Former Morrisons Supermarket, Baldock Road, Royston - Materials

Rivius Antique Slate

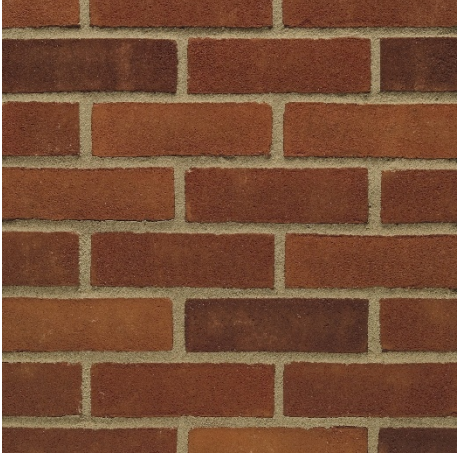
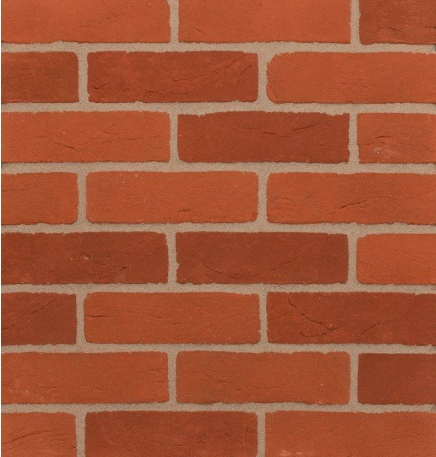
The sample below was provided by email following your rejection of the first tile submitted. This has a the slate appearance required.

Bricks

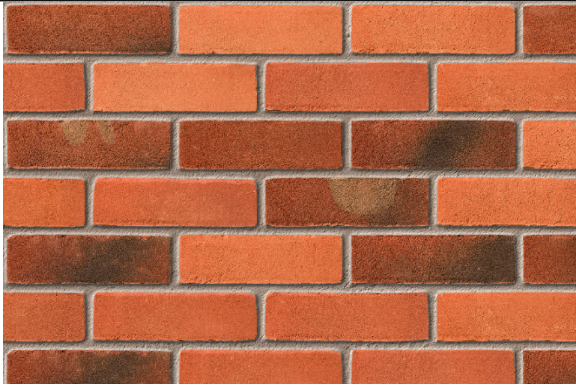
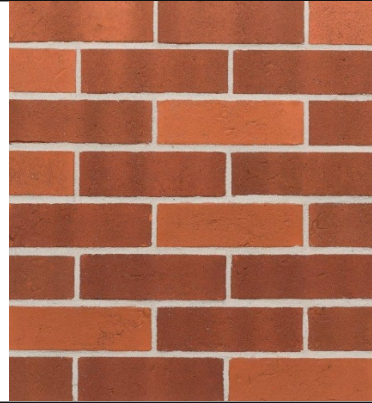
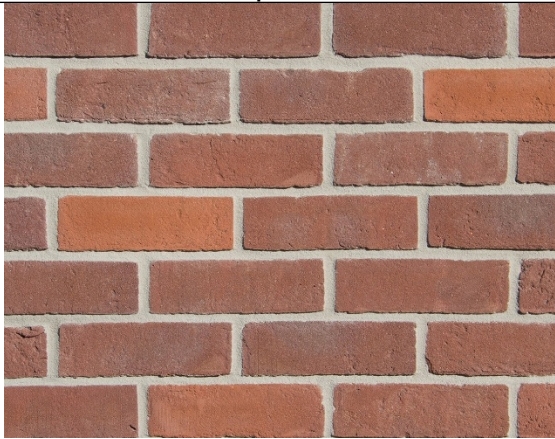
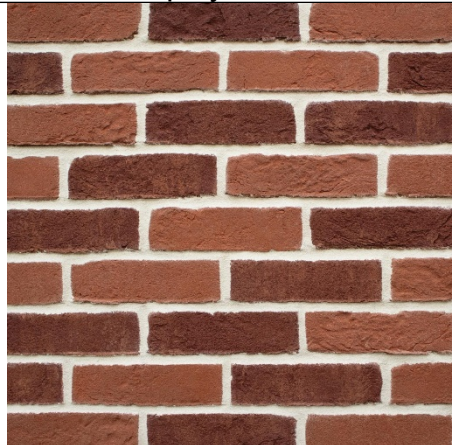
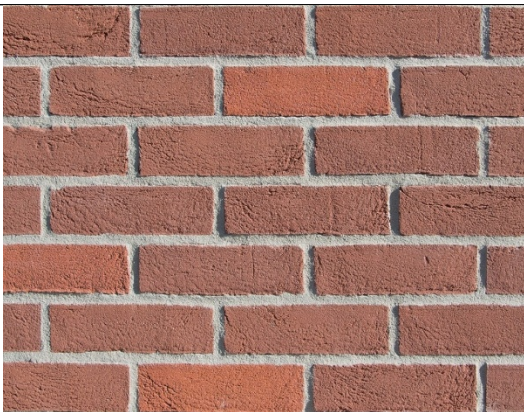
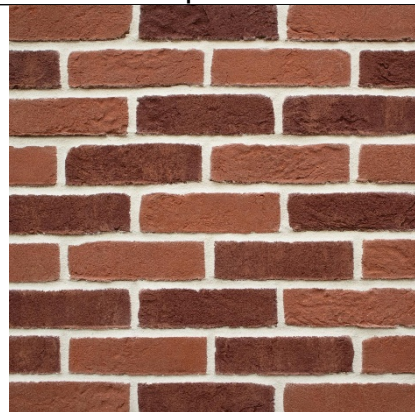
I note your comments on the bricks provided initially, please see below a selection of bricks that are available to us and would welcome your choice of any of these.

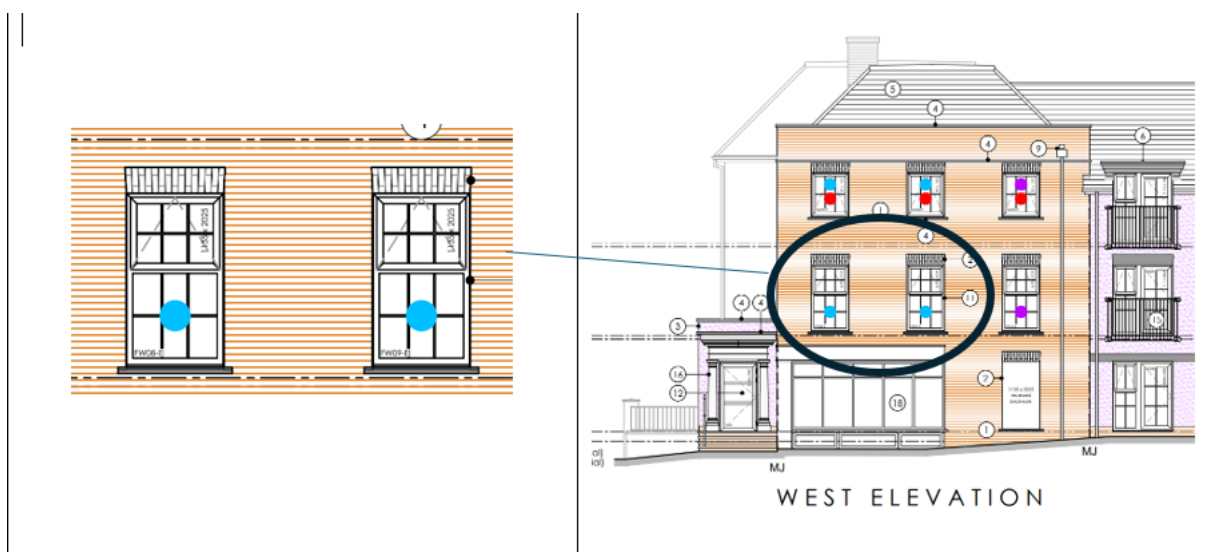
The problems we are having is not necessarily in finding an alternative to timber; the greater issue is in finding a sash style that allows us to maintain compliance with building regs, (regarding protection of fall from height etc) and provide a window that is operational for our future residents.

The windows noted in the approved elevation below are full height to the apartment; so a sash design would result in an opening at floor level within the apartment, which would need to be restricted opening to prevent risk of falls and would have poor air circulation.
